TOWN AND COUNTRY PLANNING ACT 1990 (AS AMENDED)

PROPOSED S73 REVISIONS TO PLOT 3 (THE HOTEL) IN THE NORTHUMBERLAND PARK DEVELOPMENT (LPA REF. HGY/2015/3000)

TOTTENHAM HOTSPUR STADIUM, 748 HIGH ROAD, TOTTENHAM

Figure 1: Proposed amendments to the building

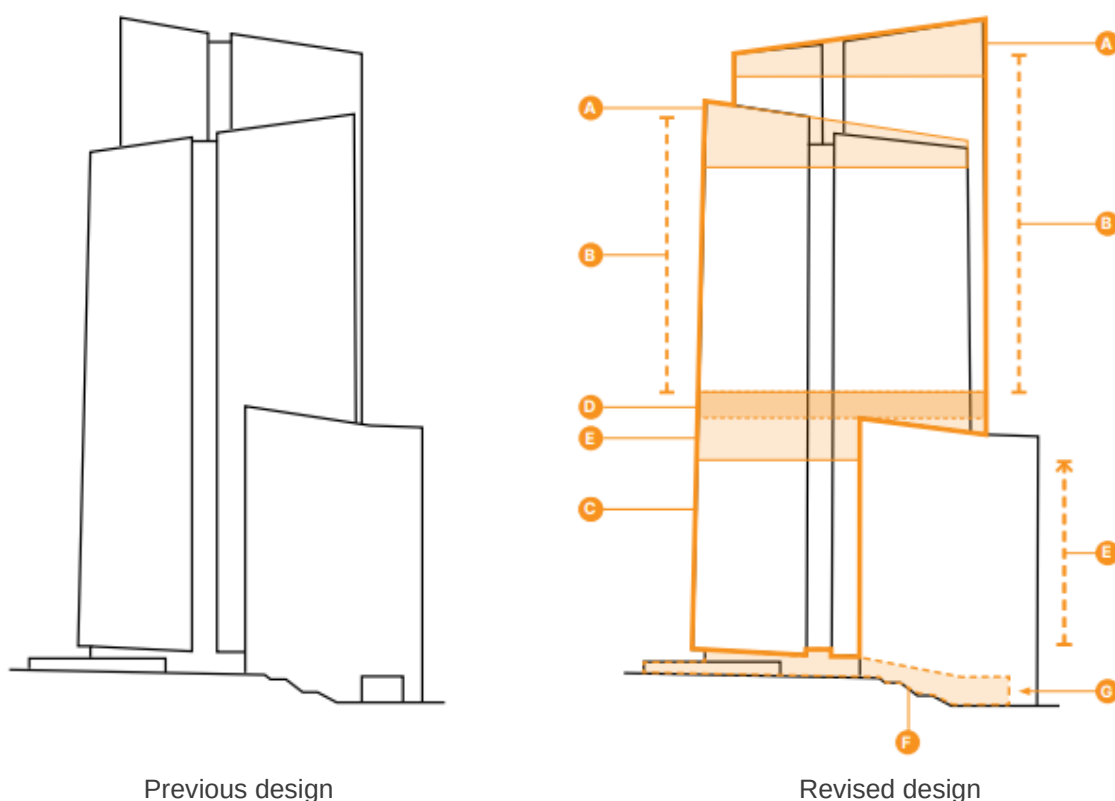
- **A. Top of Tower:** The top of the 'planar blades' have been mirrored and articulated to accentuate the building more as a landmark for the area. This consequentially changes the internal layout and aspect of the units and the façade detail and lighting. The plant rooms have also been relocated and the provision of PV panels has been added to the canopy roof. The overall height of the building does not change from the submitted scheme (127.20m AOD).

- **B. Balcony Materiality and Planters:** The residential balconies have been amended with a bronze finish to match the 'folding blades' and top of the tower. A dark grey upstand measuring 400mm to the inside of the balustrade to conceal the freestanding planters has been included.

- **C. Facade Materiality and Articulation:** The overall building energy efficiency, U-Value and thermal performance has been refined through the development of the façade. This has been achieved through:

- The use of solid aluminium panels instead of the curtain wall system;
 - The use of glazing only where vision panels are required;
 - The combination of polished, matte and brushed aluminium panels;

- The provision of solid openable panels within all habitable rooms; and
 - The rationalisation of all wall types by reducing the amount of glazing.
- **D. Residential Amenity Layout:** The Level 13 residential amenity terrace is now directly connected with the vertical core. This means that residents can access the residential amenity terrace without the need to pass through other internal spaces.

- **E. Hotel and Hotel Amenity Floors:** The number of hotel rooms has been reduced from 20 to 18 rooms per floor (now spanning Levels 02-11). The total number of hotel rooms does not change (180no.). The hotel amenity spaces have also been improved through the following design changes:

- The pool has been rotated 90 degrees to maximise views towards Central London;
 - A mezzanine floor has been added;
 - The line of facade has been extended to increase floor area, and provide a double-height internal space; and

- Minor adjustments to height of levels with no change to overall height of building
- **F. Ground and Podium Facade Interface:** The large grey columns have been omitted and replaced with a continuous light grey pre-cast concrete and glazed plinth to unify podium and ground level. The finish and character of this plinth will match the materials

within the Stadium. The entrances have been further articulated as a result. Additional planting is proposed at podium level and on the terrace.

- **G. Consolidated Access for Hotel and Amenity:** The hotel and amenity lobbies have been combined to create a grand architectural expression and hierarchy to all entrances at the base of the building. Cycle parking including visitor cycle parking is located internally and accessed through a cycle lift.
- **H. Artist Engagement:** A defined scope and brief for the arts interventions within the scheme is being developed by the Applicant.
